MOUND LABORATORY-MONSANTO
Central File No. 60-4-156 #104

Dear Dave:

(Top view)

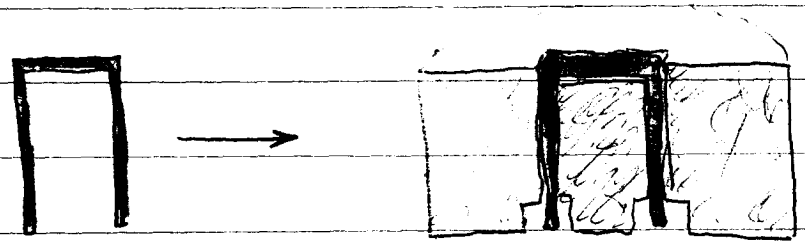
In many ways, our detonator fabrication and design principles are archaic. Could we eliminate the solder problems, for example by making the gold leads and bridge wire integral, molding all in place, and grinding to finish tolerances, if necessary?

→ surface grind if necessary to control thickness of bridge wire.

Alternatively, it might be possible to fabricate the wire and the molded part separately, then assemble them with an epoxy cement (or other) which would completely bond the wire to the plastic and seal it.
